Maitahi Village - FTAA – 2502 – 1009

Request for further information - NCC

Council Response to Minute 5

Maitahi Village – FTAA-2502-1009 Nelson City Council Response to Request for Further Information

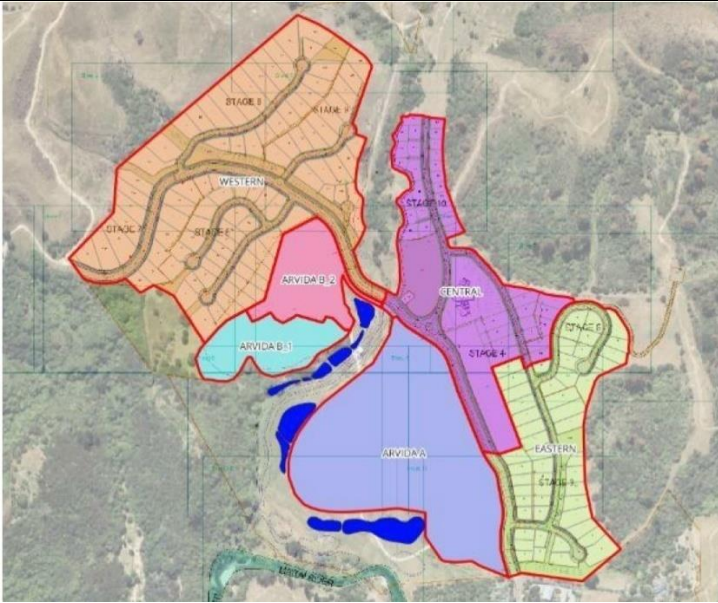
The applicant's stormwater report, prepared by Tonkin & Taylor (T+T), has been reviewed by Council's Infrastructure Engineer, who has raised a number of queries regarding the design and safety of the proposed open channel systems. These are summarised below.

Three primary open channel systems are proposed across the site, with the following design parameters:

Davis Ogilvie has attached preliminary cross sections along all roads. The dimensions of the open drains are designed in accordance with the T+T report.

Detailed cross – sections will be prepared at the detailed design stage and will incorporate the T+T rock armor design as required. Forming low points in road crossings at culverts is not practical given steepness of site.

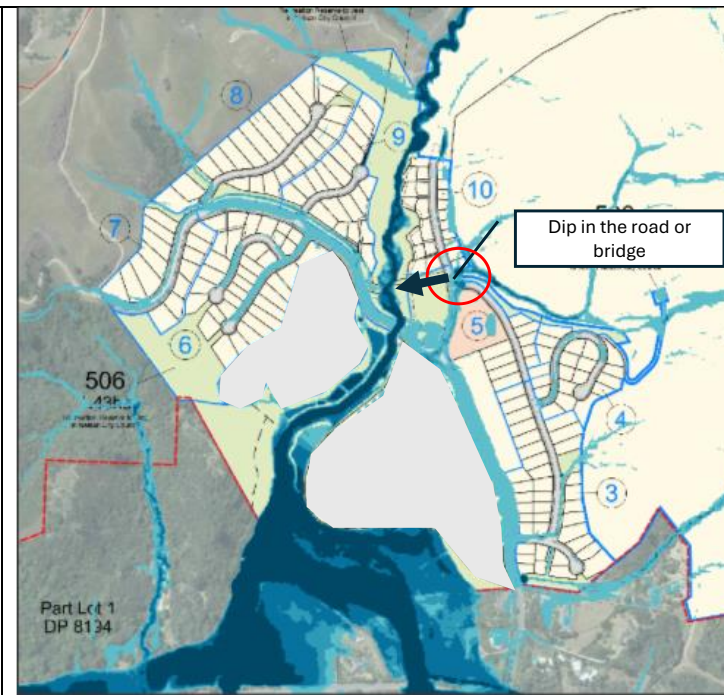
To understand the proposed bund further, it would be key to provide a typical cross section to scale with dimensions of the bund including:

- a. The bund profile
- b. The dimensions from the base of the bund (on both sides) to the proposed reserve/lot boundary.
- c. The profile of the open stream and adjacent slopes
- d. Any specific types of surfacing required, including scour protection.
- e. Show where/how access will be provided for all future ongoing operation and maintenance requirements, including who will be responsible for this maintenance and access for machinery to remove debris following a design event.
- f. What is the volume of debris that is being designed for. Please specify the design event AEP, giving consideration to NTLDM sections 5.4.4 and 5.4.6.

Given the critical nature of this bund the applicant should confirm the basis of design for the channel and bund including risk analysis of breach of the bund and secondary flow paths if the channel is blocked by debris.

Assessment against the 1-in-500-year storm events as per NTLDM Section 5.4.4 will be completed for relevant sections. T+T will undertake this flow modelling and assess effects on culverts and bridges. Findings from the debris flow assessment will be considered and addressed as part of detailed design. This is likely to involve a risk-based approach to manage sediment load and intake resilience. Depending on the outcome of this assessment, this is likely to involve specific design requirements such as: secondary intakes, screening, excavator access to the intake, oversized culverts to ensure no surcharging or concrete lining of road sections that act as overland flowpath.
